UNITED STATES PATENT AND TRADEMARK OFFICE

APPLICATION NO.	FILING DATE	FIRST NAMED INVENTOR	ATTORNEY DOCKET NO.	CONFIRMATION NO.	
10/629,214	07/29/2003	Calvin L. Cagle	CAG-001	5313	
75	90 03/09/2005		EXAM	INER	
Jeffrey K. Seto			ADAMS, GREGORY W		
617 Tinkerbell I Chapel Hill, No	-		ART UNIT	PAPER NUMBER	
, 2,011			3652

Application No.	Applicant(s)	/ X		
	10/629,214	CAGLE, CALVIN L.			
Office Action Summary	Examiner	Art Unit			
<u> </u>	Gregory W. Adams	3652			
The MAILING DATE of this communication appears on the cover sheet with the correspondence address Period for Reply A SHORTENED STATUTORY PERIOD FOR REPLY IS SET TO EXPIRE 3 MONTH(S) FROM					
THE MAILING DATE OF THIS COMMUNICATION. - Extensions of time may be available under the provisions of 37 CFR 1.1 after SIX (6) MONTHS from the mailing date of this communication. - If the period for reply specified above is less than thirty (30) days, a repl - If NO period for reply is specified above, the maximum statutory period - Failure to reply within the set or extended period for reply will, by statute Any reply received by the Office later than three months after the mailin earned patent term adjustment. See 37 CFR 1.704(b).	13

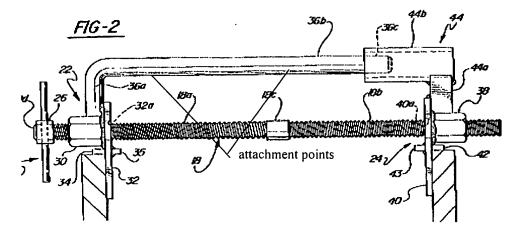
- 5. With respect to claim 3 & 8, referring to FIGS. 1-2 Boyden et al. disclose a brace further comprises attachment points as shown below. It is noted that a lifting force would be applied through these attachment points and could be applied manually.
